Access Compliance Report

Public Rights-of-Way

(Curb Ramps)

Intersection ID: 2703	Main Street: CROWNVISTA_DR	Cross Street: STARGAZE_LN	Location:	E
ADA ID: AB515FCA145E	Ramp Type: PerpDiag	Initial Pass/Fail: Fail	Overall Compliance: No	Severity Score: 21.25

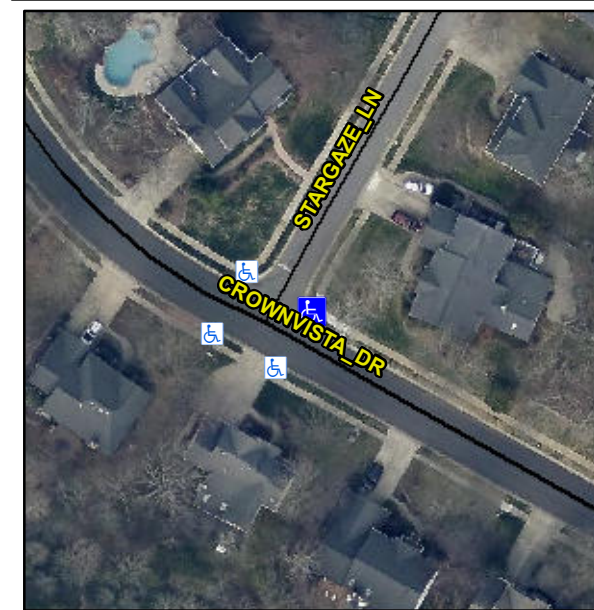
Not Found, R304.5.1, R304.2.2

Compliance	Description	Data	Compliance	Description	Data
N/A	Ramp Length (in)	46.0	No	Ramp Slope (%)	8.5
No	Ramp Width (in)	40.0	Yes	Ramp XSlope (%)	0.1
N/A	Flare Type LT	N/A	N/A	Flare Type RT	N/A
N/A	Flare Slope LT (%)	N/A	N/A	Flare Slope RT (%)	N/A
N/A	Flare Traversable LT?	N/A	N/A	Flare Traversable RT?	N/A
N/A	Landing Length (in)	N/A	N/A	DWS Provided?	N/A
N/A	Landing Width (in)	N/A	N/A	DWS Contrast?	N/A
N/A	Landing Slope (%)	N/A	N/A	DWS Length (in)	N/A
N/A	Landing X Slope (%)	N/A	N/A	DWS Full Width?	N/A
N/A	Landing Curb? (Y/N)	N/A	N/A	DWS Offset (in)	N/A
N/A	Shared Landing?	N/A			
N/A	Gutter Ponding?	N/A	N/A	Gutter Slope (%)	N/A
N/A	Gutter Lip Ht (in)	N/A	N/A	Gutter X Slope (%)	N/A
N/A	Painted X Walk1?	No	N/A	Painted X Walk2?	No
	X Walk 1 Direction	To NW		X Walk 2 Direction	To SW
N/A	X Walk 1 Width (in)	N/A	N/A	X Walk 2 Width (in)	N/A
	X Walk 1 Slope (%)	3.2		X Walk 2 Slope (%)	4.5
	X Walk 1 X Slope (%)	3.0		X Walk 2 X Slope (%)	1.5

Remove & Replace Curb Ramp With Two New Directional Ramps or Equivalent.
